September 8, 2015

Re: City of Santa Monica Comments to the Southern California Metroplex Draft Environmental Assessment

Appendix 1
Proposed SMO Alternatives Shown in EA Exhibit 3-8

Plots of SMO Proposed Procedures From Exhibit 3-8

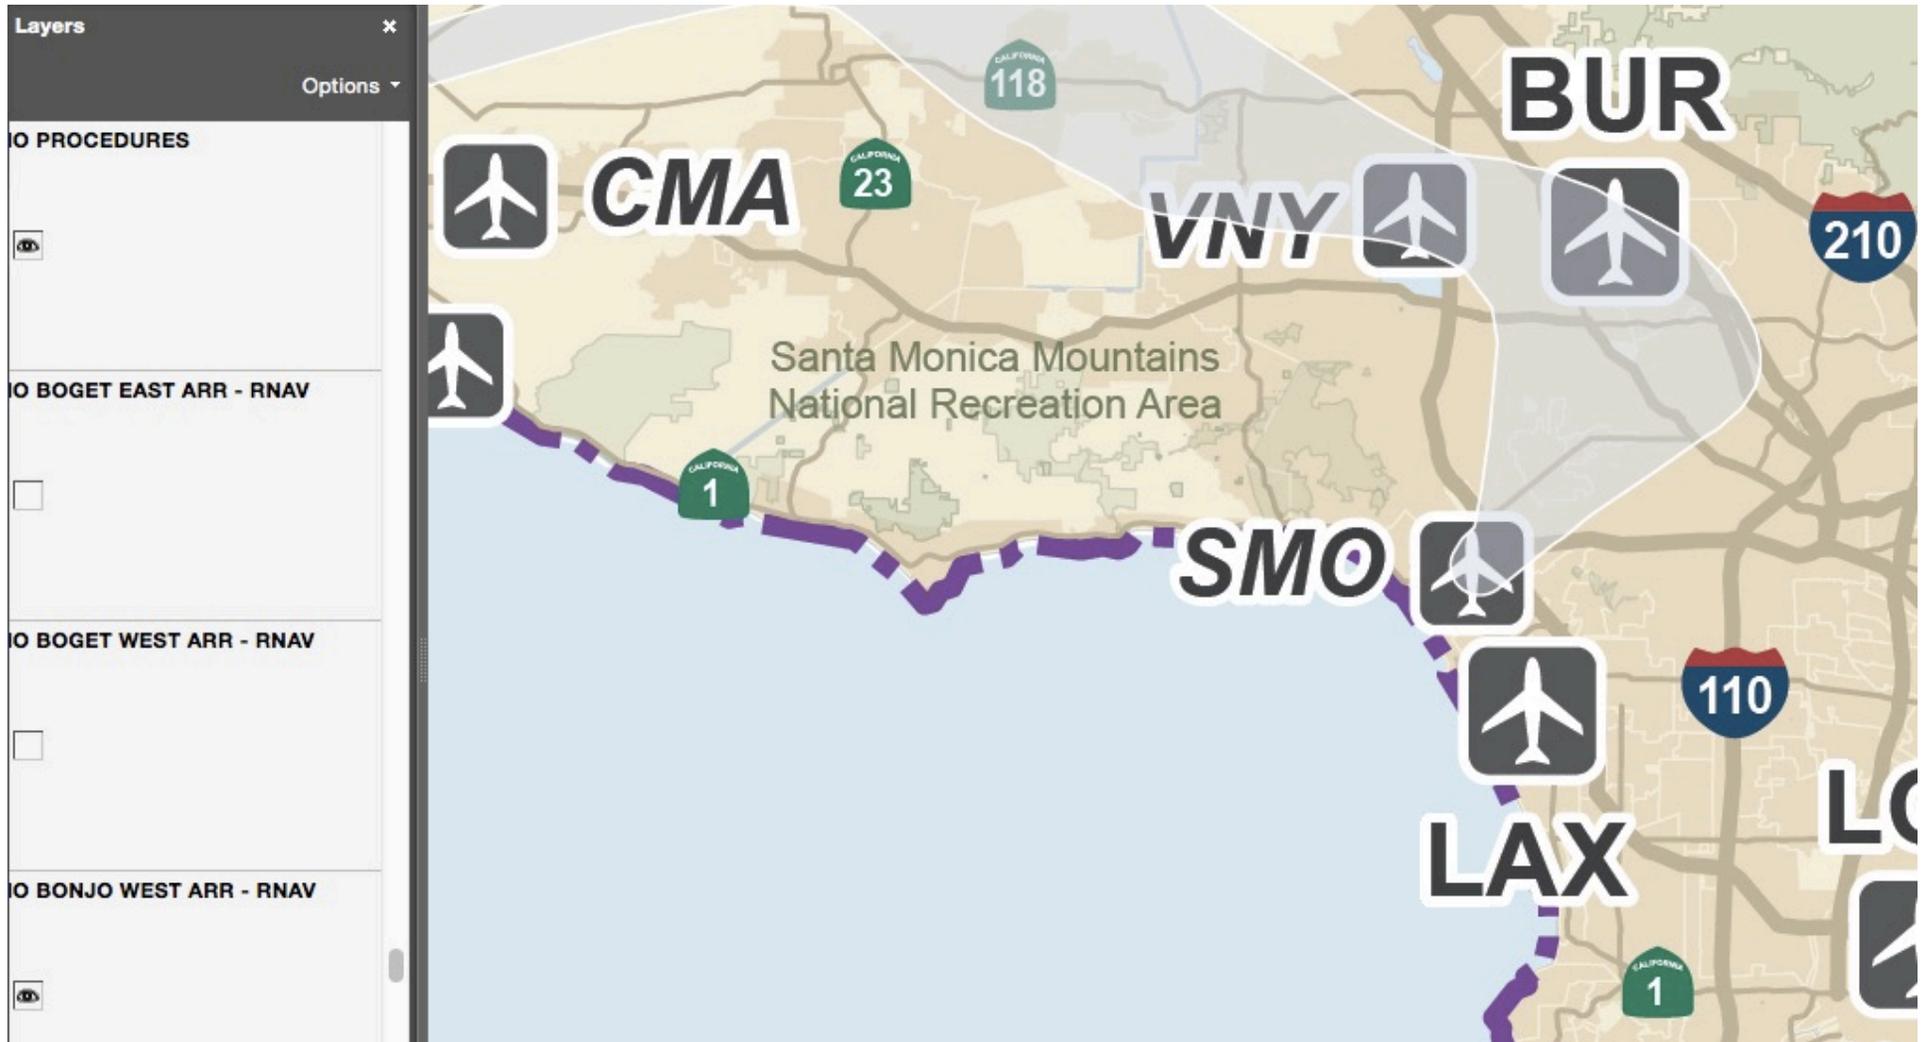
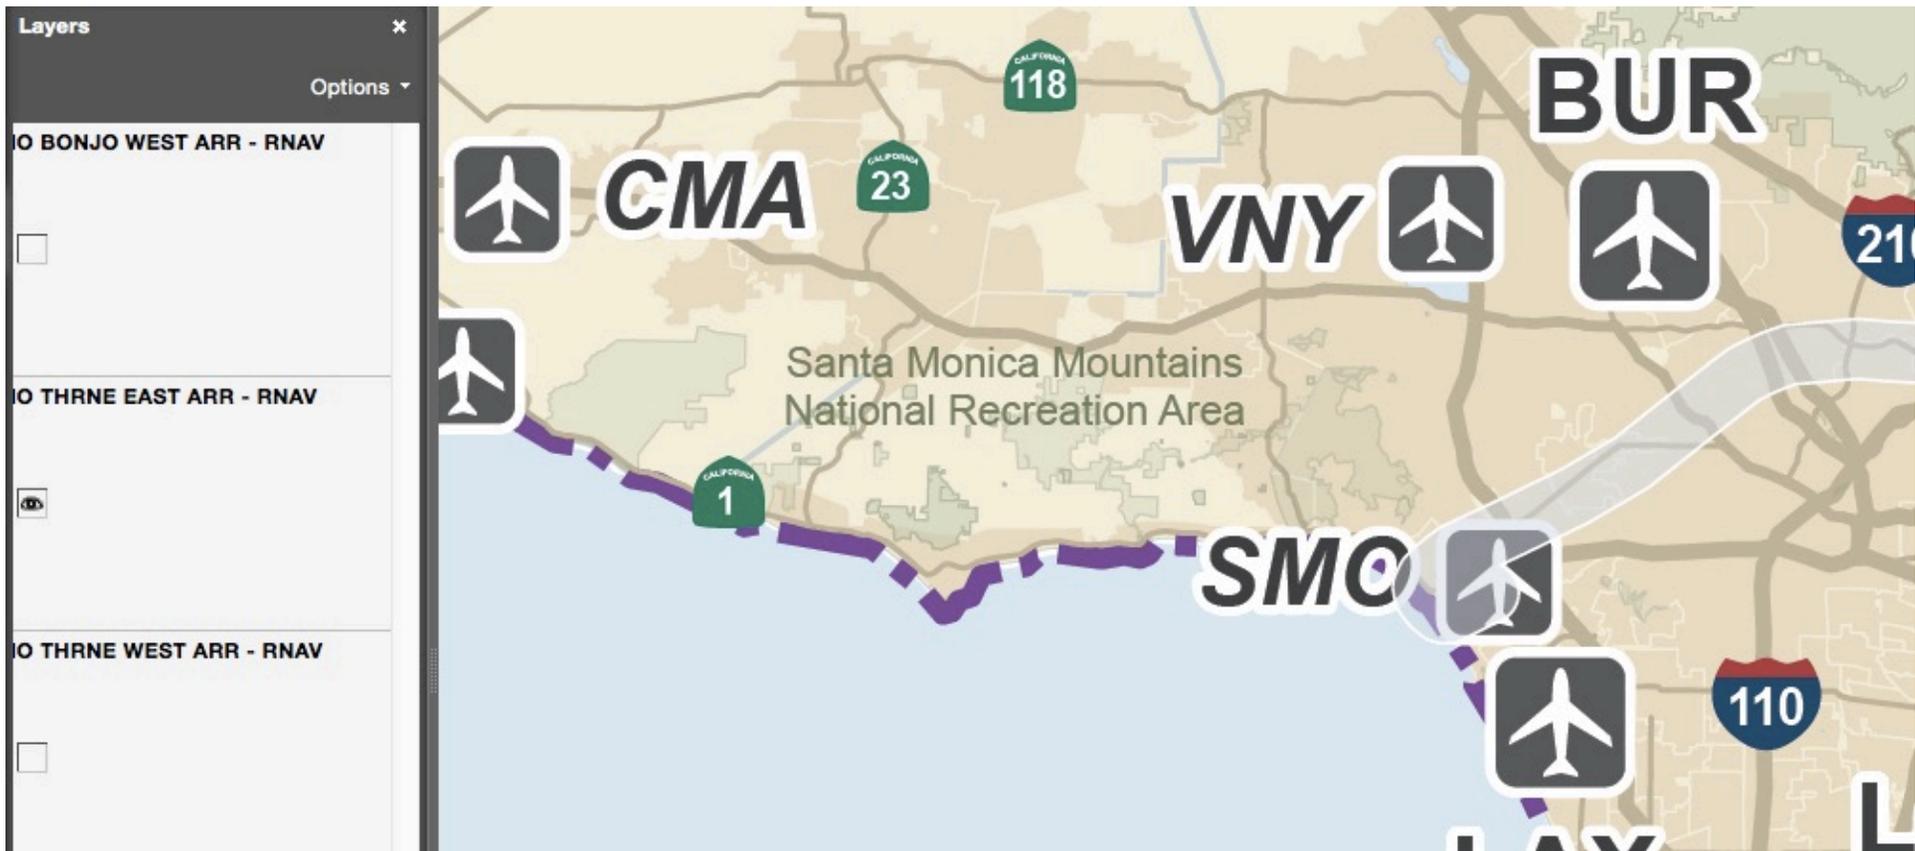
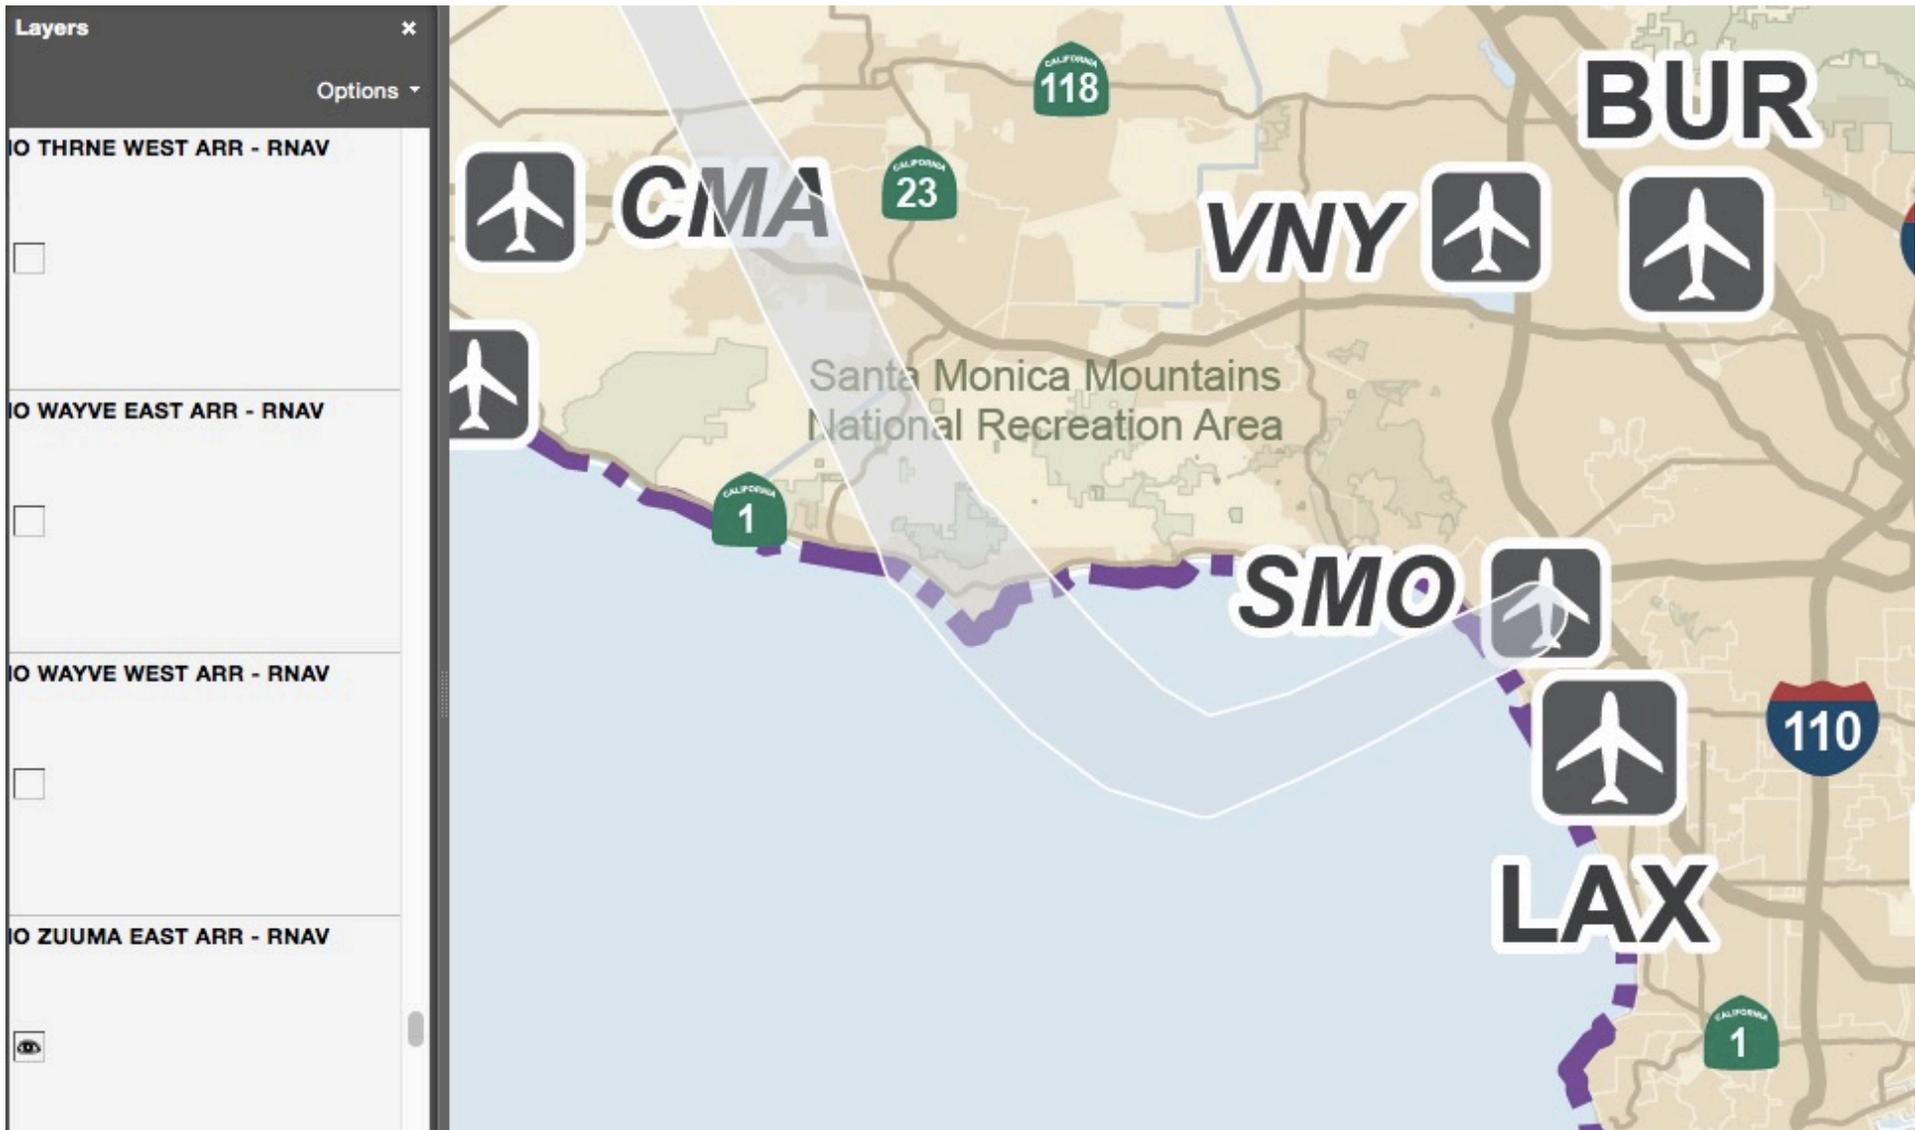
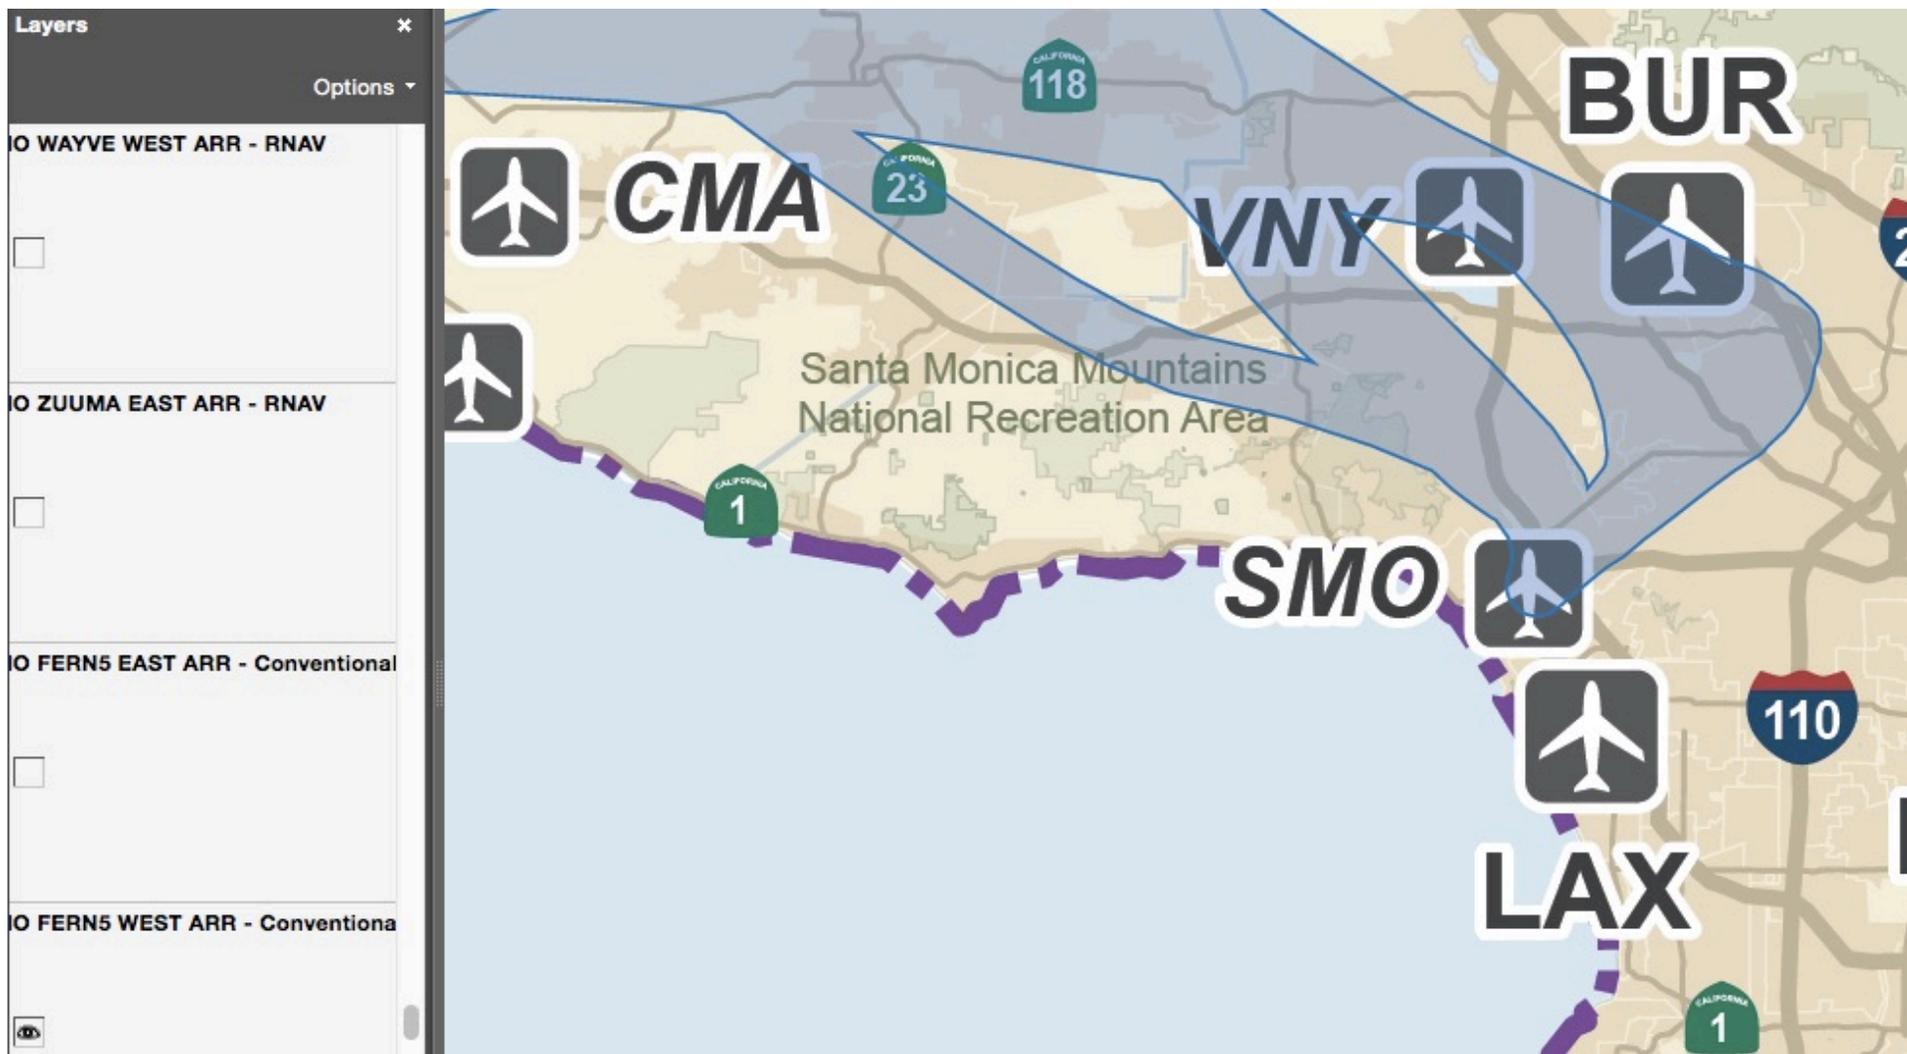
Exhibit 3-8 shows, for readers that are proficient in using Adobe Acrobat layers (and is blank for most users), that there are 15 procedures that affect SMO. Appendix 1 shows the 15 procedures proposed for SMO (these are screen shots from Exhibit 3-8). There is no explanation for the discrepancy between Tables 3-2, 3-3 and Exhibit 3-8 where Exhibit 3-8 shows 15 procedures for SMO, but Tables 3-2 and 3-3 only list 12 such procedures. And, the proposed RNP procedures listed in Table 3-3 are not shown, or incorrectly labeled in Exhibit 3-8.

The route descriptions provided in Exhibit 3-8 (screenshot copied directly in Appendix 1) are entirely inadequate for purposes of the EA. The scale of the map has insufficient resolution to identify the locations of any of the procedures proposed for any of the airports. A reader cannot determine if a proposed route affects his or her home or not. This exhibit does not inform the reader and it is the only place where the reader has any hope of figuring out what the FAA is actually proposing.

The route descriptions shown in Exhibit 3-8 (Appendix 1) are shown as very wide corridors and not shown as the SID, STAR, or RNP route that would be published as a result of this project. While it is true that a SID or a STAR will have more dispersion than an RNP route, the broad overly wide corridors shown in Exhibit 3-8 make it impossible for the reader to know where the proposed route actually is located. More importantly, since this is the only place in the EA where the routes are mapped and they are shown as such broad areas, the EA could conceivably be used now or in the future to provide environmental clearance for any route that falls within these broad areas.
